IM-0069-04(005)/ 109260301000

**SECTION 904 - NOTICE TO BIDDERS NO. 6700**

**SUBJECT: Scope of Work**

**PROJECT: IM-0069-04(005) /109260301 – Desoto County**

MISSISSIPPI DEPARTMENT OF TRANSPORTATION	
<b>MISCELLANEOUS DETAIL</b>	
PROJECT NO.	_____
SHEET NO.	_____
TITLE	_____

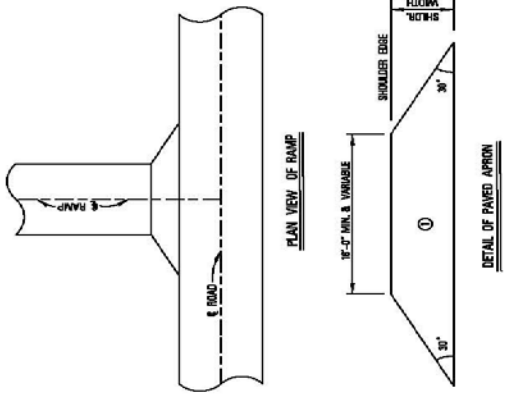
① 1'-1/2" A VARIABLE DEPTH ASPHALT PAVEMENT REQUIRED
